Regional Review Notification

Development of Regional Impact

Name of Proposal: Project Rockforge DRI 4456

Description: A DRI review of a proposal to build 4,089,000 SF of data center space in eight two-story buildings on 263-acre mostly forested site traversed by several streams at the SW corner of the intersection of Irwin Bridge Road and Farmer Road in Rockdale County.

SHEET CP-1

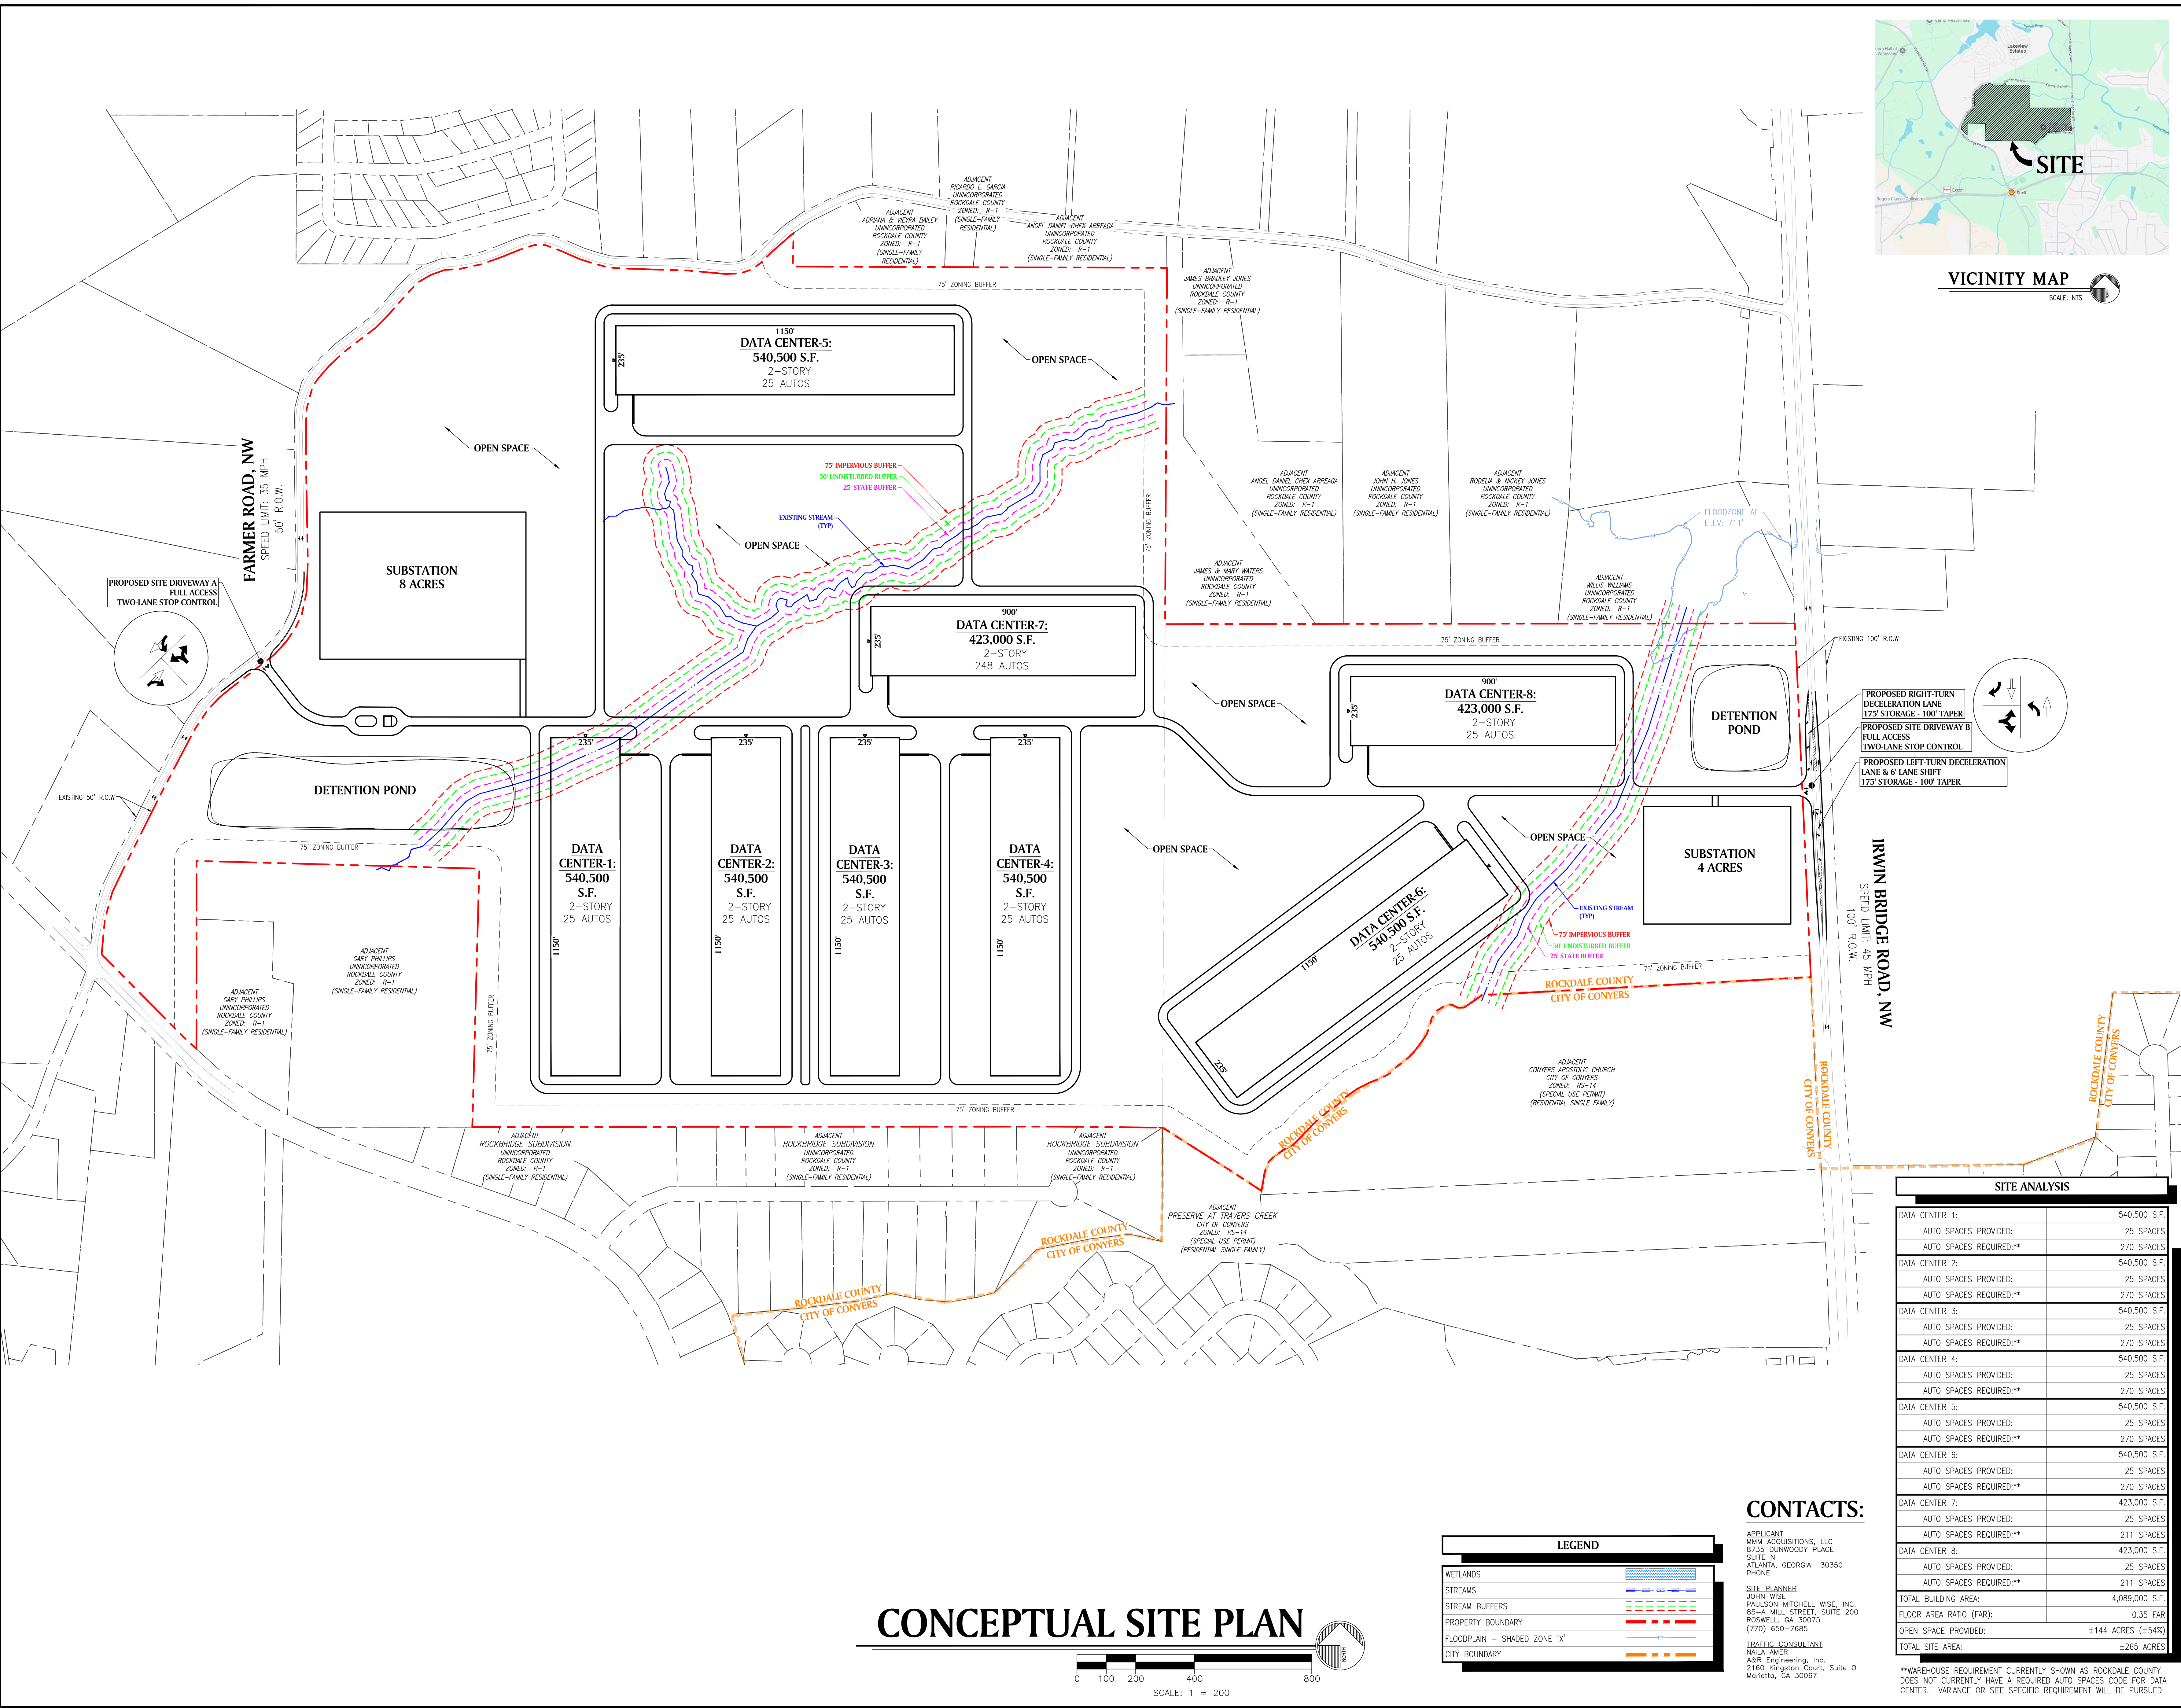
The project's provision of 144 acres of open space is supportive of regional environmental policies. However, the project's negative impacts on several streams is not supportive of regional environmental policies.

The project's provision of 144 acres of open space is supportive of regional environmental policies. However, the project's negative impacts on several streams is not supportive of regional environmental policies. It could be made more supportive of regional environmental policies by reducing stream impacts.

The project is not aligned with Established Suburbs recommendations in that it does not complement adjacent residential neighborhoods. While it preserves a large amount of open space, it also proposes destroying multiple stream areas. It could be made more supportive of regional environmental policies by reducing stream impacts. Rockdale County leadership and staff, along with the applicant team, should collaborate closely to ensure maximum sensitivity to the needs of nearby local governments, neighborhoods, land uses and natural systems.
